Proposed raised entrance through Cofferridge Close Archway

Comments on this proposal from 'Save Cofferridge Close' Group

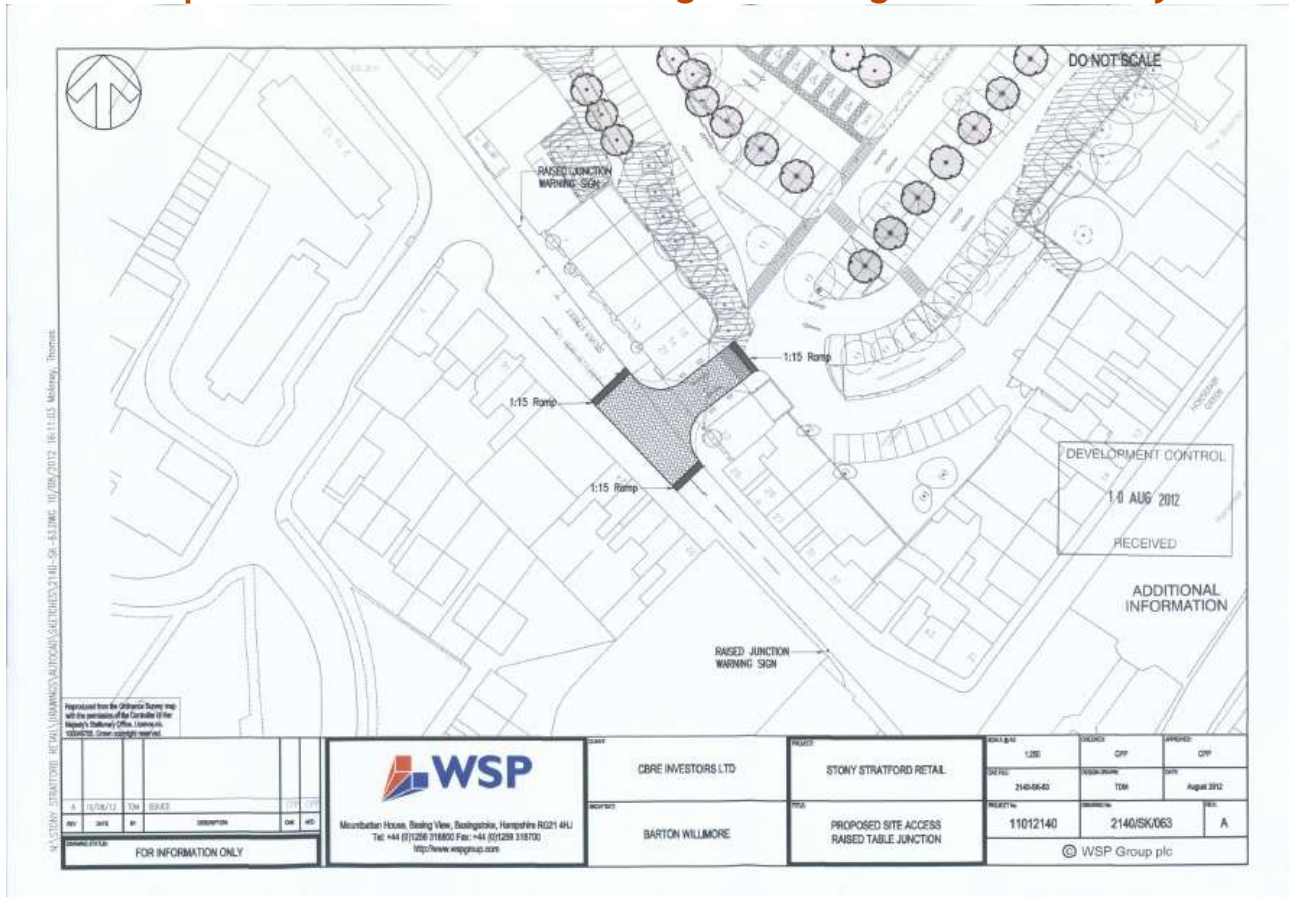
Road Safety : The purpose of raised tables at junctions is to reduce traffic speeds through the junction, and to draw drivers' attention to the fact that there is a junction and thus increase road safety. In this instance we believe that neither of these objectives are necessary or met. Traffic speeds on Silver Street are already very low because of the restricted road space resulting from the narrowness of the road and on-street parking. The presence of the junction is already fairly obvious and could be made more so by some additional signing. It seems that this proposal is a part of the developer's wish to impose a one-way system which would inevitably result in increased traffic speeds on Silver Street, and the implementation of this proposal would enable them to say that traffic speeds would be unaffected!

Damage to Archway : We also think that the provision of a junction table could make it more difficult for HGV's to get through the archway safely, since the driver would have to concentrate on negotiating the ramp and, because he will be turning, the ramp will induce a rocking movement on his vehicle which will significantly affect the positioning of the upper part of the wagon, particularly an articulated vehicle. This could increase the risk of the top of the truck hitting the underside of the arch, and even getting stuck there.

Disturbance to local residents : The raised road surface in Silver Street would increase noise disturbance from vehicles changing gear and 'bumping over' the ramps: this could become a major source of annoyance to residents on either side of Silver Street, especially at night. And the proposed raised junction warning signs will be yet another obstacle for pedestrians to negotiate on the narrow pavements.

Grade II Listing : The archway into the Close forms part of the row of Grade II listed houses, which should have a bearing on whether or not this proposal can be approved.
